Proposal for an amendment to ECE/TRANS/WP29/2022/7

The changes compared to documents ECE/TRANS/WP.29/2022/7 are marked in **strike through red font** for deleted text.

Figure, amend to read:

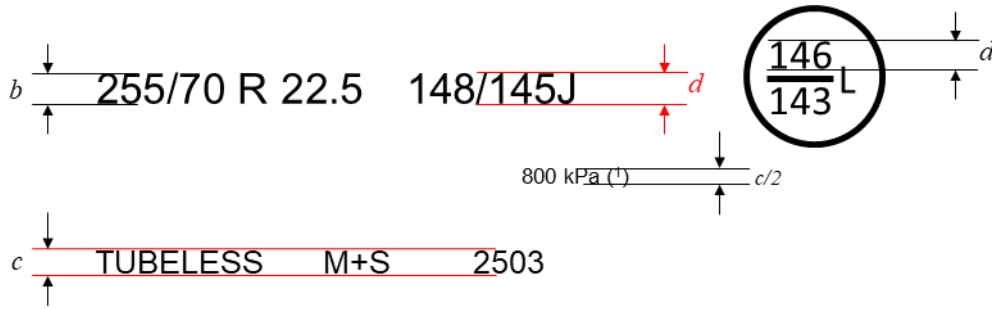
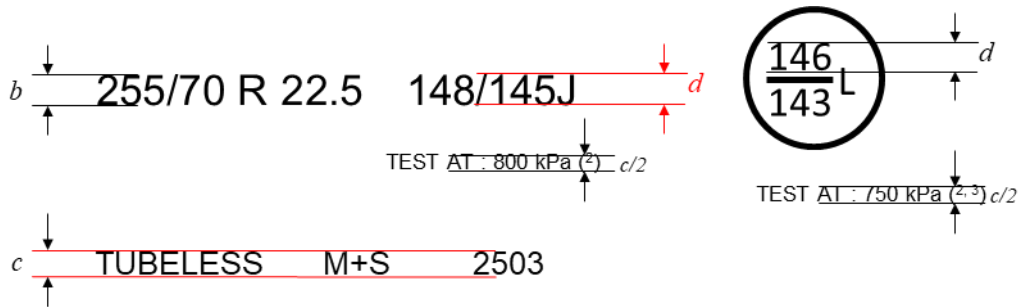
"Example 1:

- (1) PSI marking instead of kPa is allowed for tyres first type approved before 1 January 2018. The kPa marking may be preceded by "TEST AT : " or, alternatively, by "TEST INFL : " or the symbol "@".

Example 2:

- (2) "TEST AT : " may be replaced by "TEST INFL : " or the symbol "@" or be omitted.
 (3) The indication of a second inflation pressure for the additional service description is optional. If there is no indication, the same test inflation applies to both load/speed combinations.

Dimensional requirements for further markings (4):

- (4) For "ML" and "MPT" being part of the tyre size designation marking the minimum dimension *b* applies."
